HISTORIC AND DESIGN REVIEW COMMISSION

HDRC CASE NO: 2022-130
ADDRESS: 334 W ELSMERE PLACE
LEGAL DESCRIPTION: NCB 3967 BLK 2 LOT E 25 FT OF 3 & W 25FT OF 4
ZONING: R-5,H
CITY COUNCIL DIST.: 1
DISTRICT: Monte Vista Historic District
APPLICANT: Tom Krulevitch
OWNER: Peter & Susana Krulevitch
TYPE OF WORK: Exterior modifications, construction of a rear addition, rear accessory structure modifications and addition, site modifications
APPLICATION RECEIVED: February 10, 2022
60-DAY REVIEW: Not applicable due to City Council Emergency Orders
CASE MANAGER: Stephanie Phillips

The applicant is requesting conceptual approval to:

MAIN ELEVATIONS PROPOSED

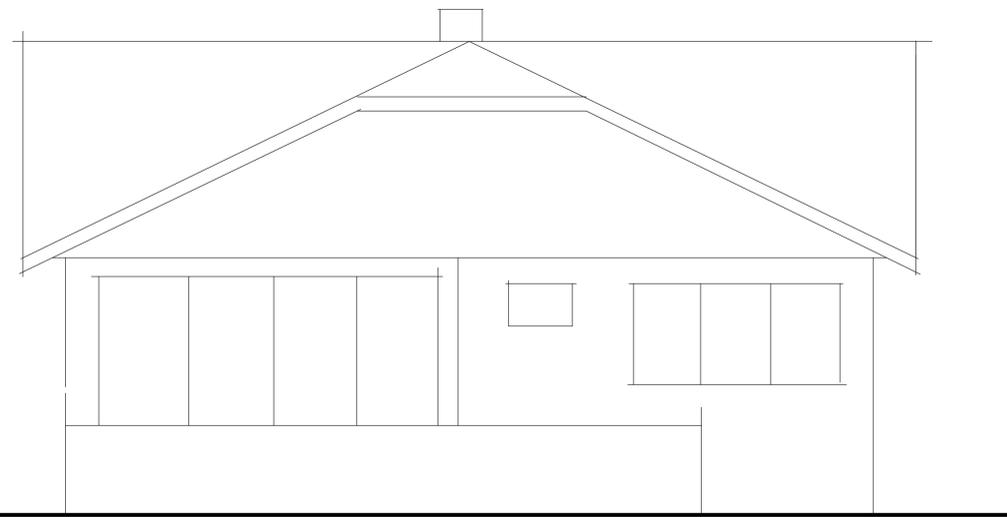
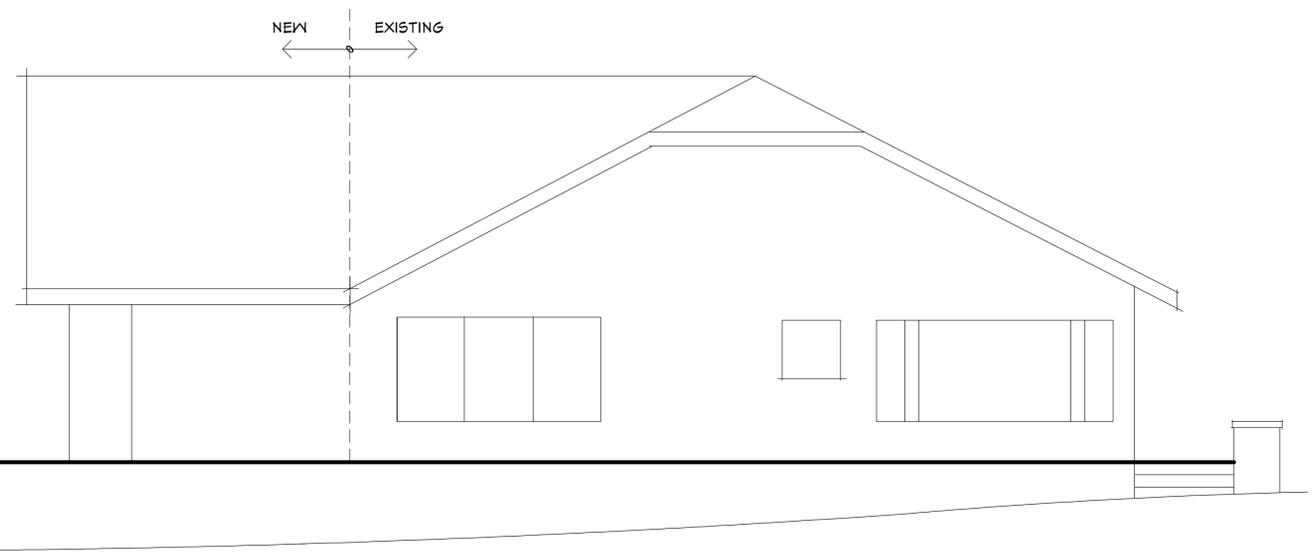
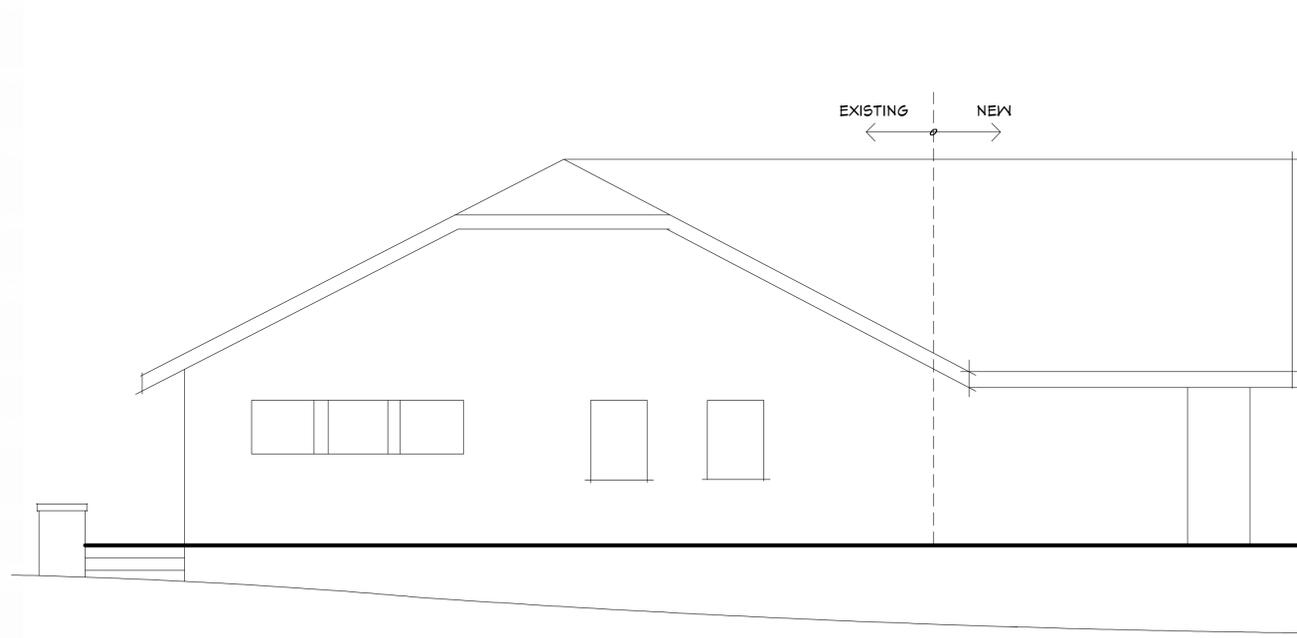
- d. ADDITION: MODIFICATIONS TO EXISTING STRUCTURE – The applicant has proposed to construct a 1-story rear addition to the existing 1-story historic house, which will require exterior modifications to the existing structure. Based on submitted photographs and the conceptual documents, the proposed modifications appear to include the removal of an existing window and door configuration on the rear elevation. Staff finds that the removal of elements of the rear addition are acceptable for the new addition and recommends that any salvageable elements be reutilized in the new addition.

- f. ADDITION: SCALE AND MASSING – The applicant has proposed to construct a 1-story rear addition. According to the Historic Design Guidelines, the height of additions should be subordinate to the primary structure or, at minimum, align with the primary ridge line. Staff generally finds the height consistent with the Guidelines based on the submitted documentation.

- g. ADDITION: ROOF – The applicant has proposed to install a standing seam metal roof on the addition to match the primary structure. The roof will feature a gable configuration. Staff finds the proposal conceptually consistent with the Guidelines.

- h. ADDITION: WINDOWS AND DOORS – Per the submitted documentation, the addition will feature accordion-style doors and a set of three windows on the rear elevation. The right and left elevations of the addition do not currently feature fenestration. According to the Historic Design Guidelines, new windows on additions should relate to the windows of the primary historic structure in terms of materiality and overall appearance. Windows used in new construction should relate to those commonly found

within the district in terms of size, profile, and configuration. As noted in finding d, the applicant should reclaim windows to be removed for the addition where feasible. While no material is expressly prohibited by the Historic Design Guidelines, a high-quality wood or aluminum-clad wood window product often meets the Guidelines with the stipulations listed in staff's specifications and the recommendation if new windows or doors are needed. Staff recommends that the applicant explore adding fenestration to the left and right elevations for final approval.

- iii. That the applicant salvage and reuse the windows to be removed for the rear addition as noted in findings d and h.
- iv. That the applicant explores adding fenestration to the right and left elevations of the addition for final approval as noted in finding h.

ADU ELEVS PROPOSED
1/4" = 1'-0"

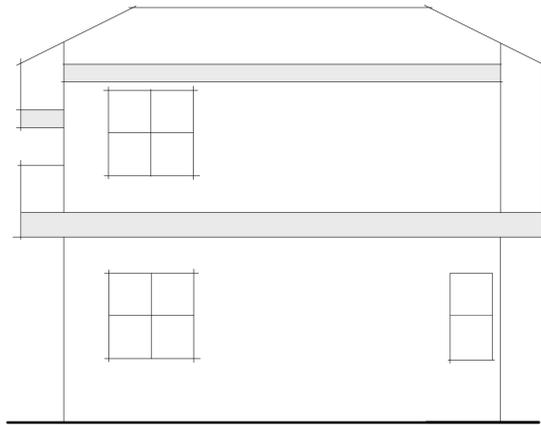
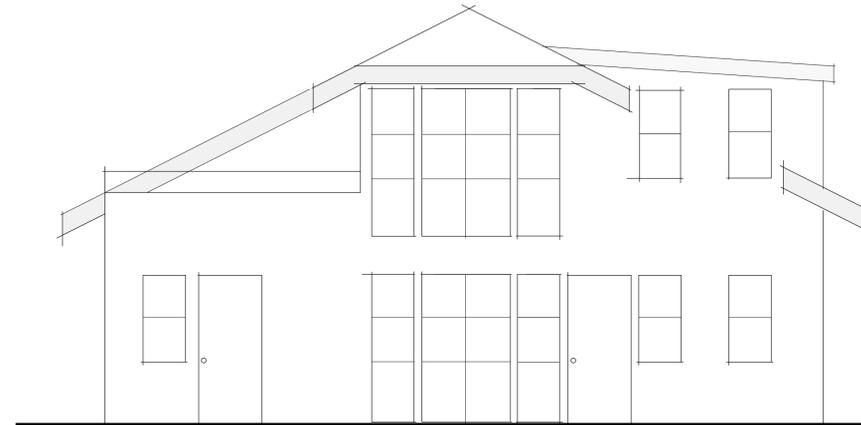
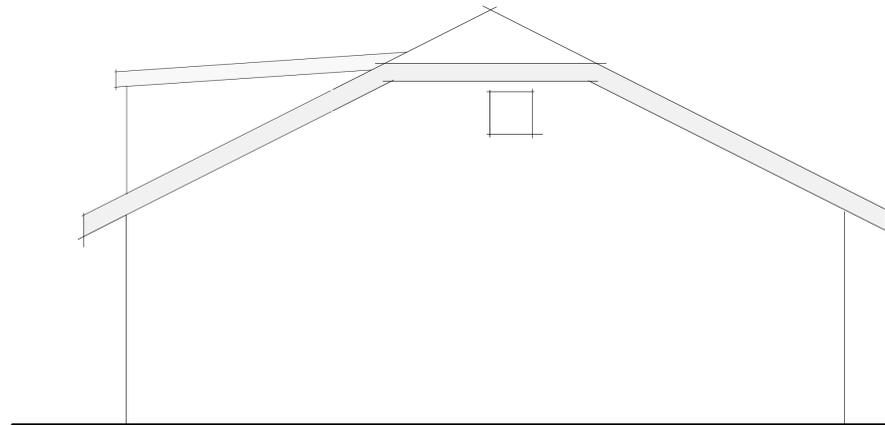
- j. **REAR ACCESSORY STRUCTURE MODIFICATIONS** – Per the submitted documents, two walls of the existing rear garage will be removed, resulting in new footprint to support a second story addition and additional exterior modifications. The two remaining walls will be retained and incorporated into the new design, which features a taller primary roofline, a new fenestration pattern, and new exterior garage doors facing the street. At this time, staff does not find the proposal conceptually appropriate due to limited visual clarity, unclear drawing convention, and an incomplete understanding of exactly what materials will be retained from the existing garage. Staff finds that applicant should aim to maximize material salvage from the walls to be removed for reuse in the new design and submit a clear salvage and reuse plan, in addition to measured, dimensioned drawings. Staff also finds that the applicant should propose modifications that are consistent with the Guidelines for Additions pertaining to roof forms, fenestration patterns, massing, scale, and materials.

- v. That the applicant submits a rear accessory structure proposal that includes clear elevations and additional information on which materials will be retained in the new design as noted in finding j. The drawings should also indicate the height of the rear structure relative to the primary structure.

- vi. That the applicant incorporates roof forms, materials, and fenestration patterns into the rear accessory structure modifications that are consistent with the Guidelines as noted in finding j.

A-1

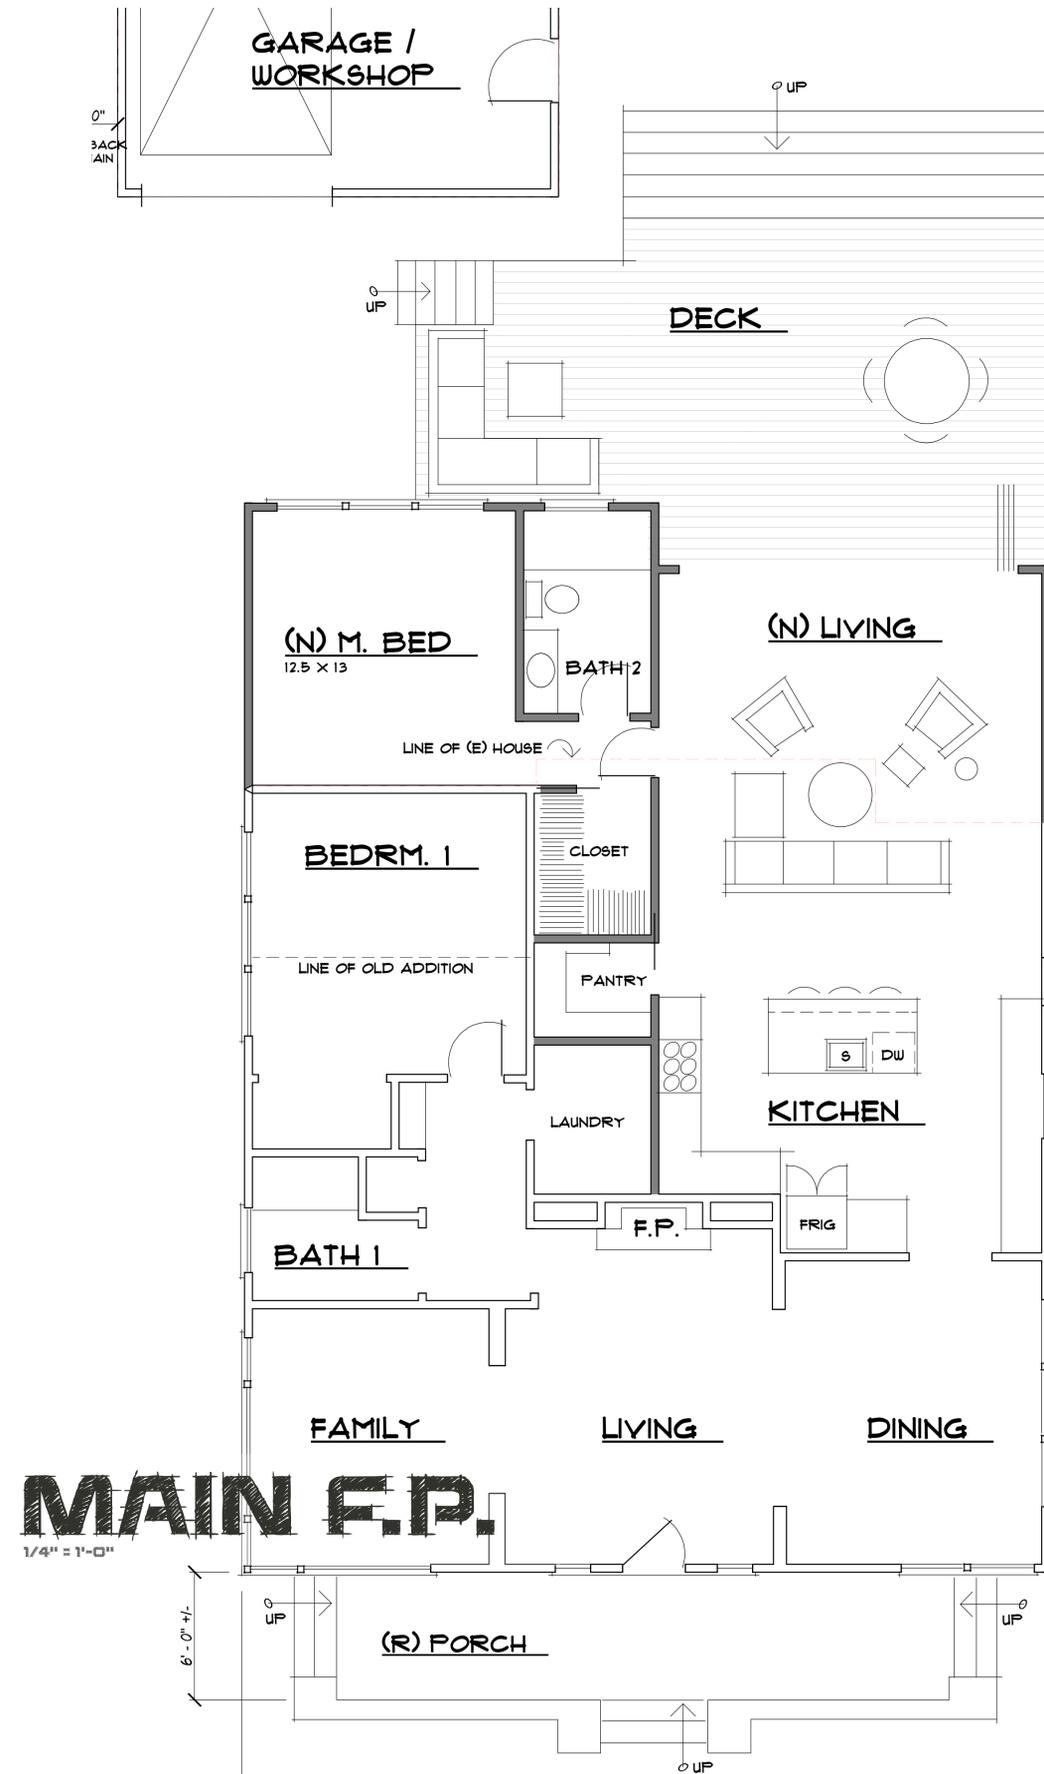
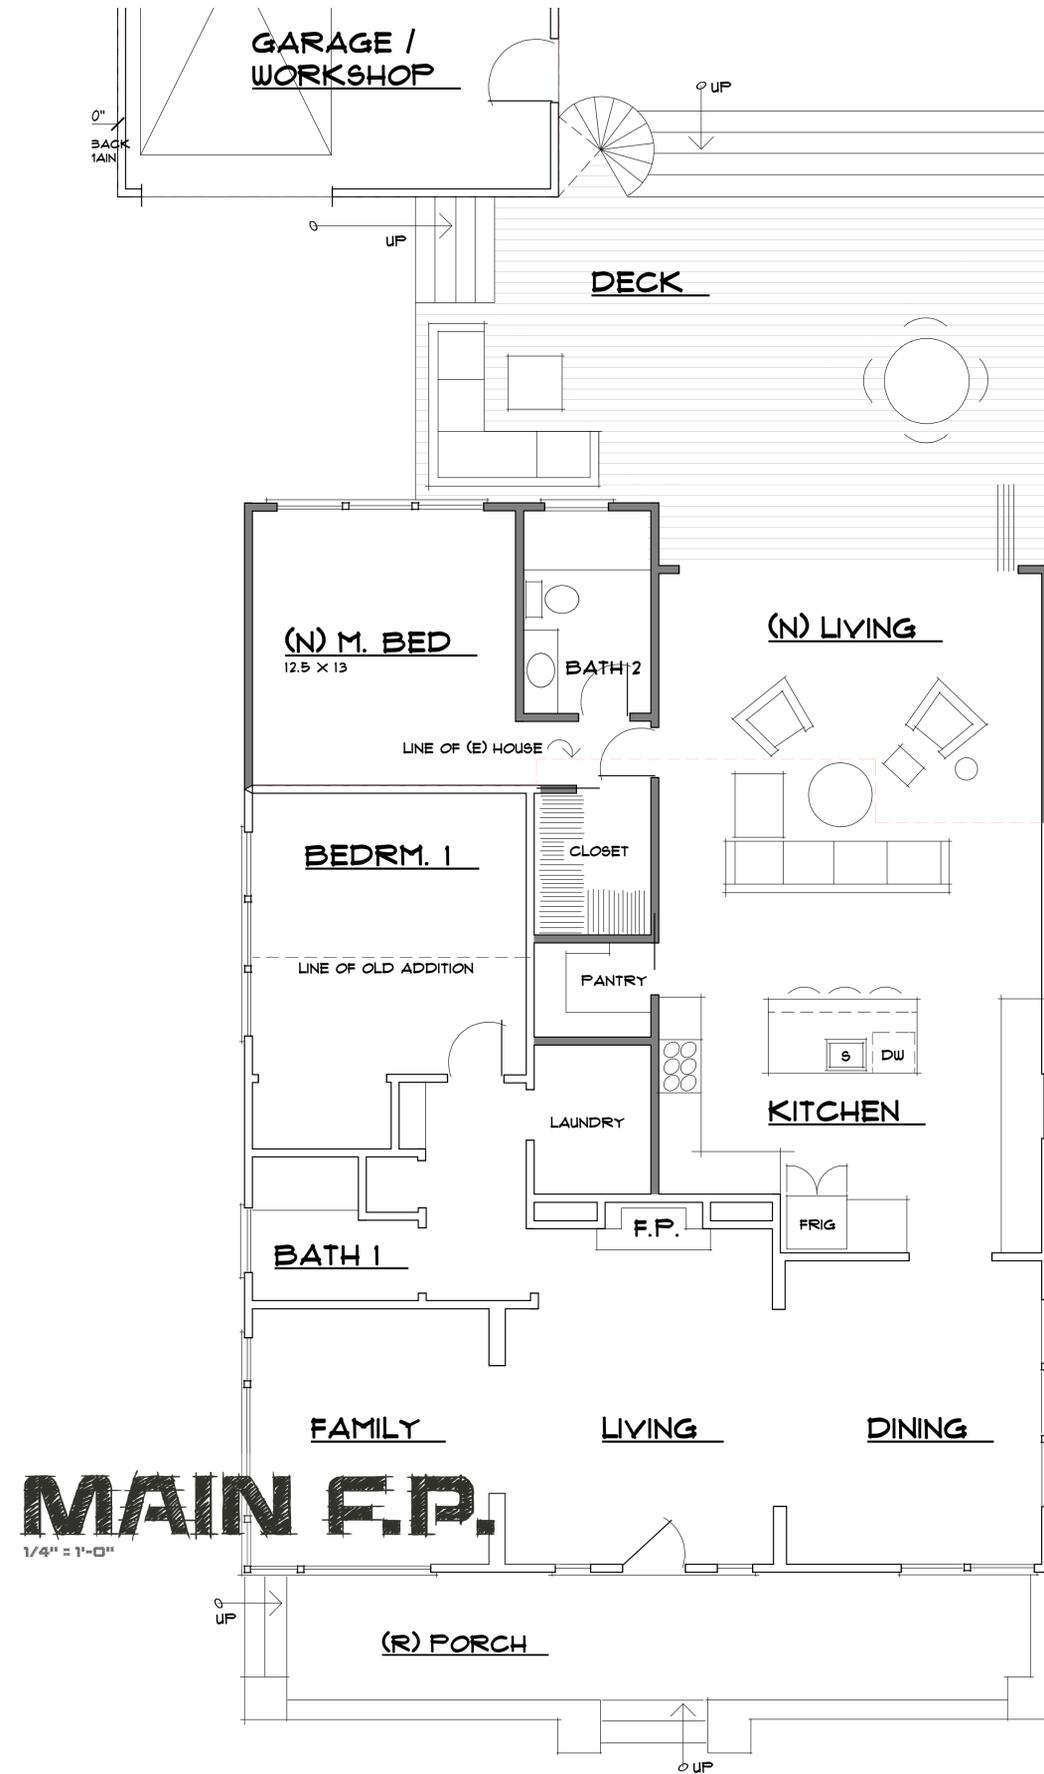
- c. FRONT PORCH MODIFICATIONS – The applicant has proposed to modify the existing front porch configuration. The current porch features an arched shed overhang and a concrete pad that is slightly larger than the overhang. The proposal will not affect the overhang. The proposal includes removing the existing steps and pad and extending the uncovered porch to the full width of the front façade. Short walls with faux column bases will be included. Per the Guidelines, front porches should be retained. Design replacement elements, such as stairs, to be simple so as to not distract from the historic character of the building. Do not add new elements and details that create a false historic appearance. The porch configuration appears to be original to the structure and is characteristic of other structures of a similar design in the Monte Vista Historic District and nearby neighborhoods of a similar development period. Staff does not find the modifications consistent with the Guidelines.

- i. That the applicant retains the existing front porch configuration as noted in finding c.
- ii. That the applicant provides clear, measured, dimensioned drawings that clearly convey what will be retained and what elements are new for both the addition and rear accessory structure modifications as noted in findings d, h, and j.
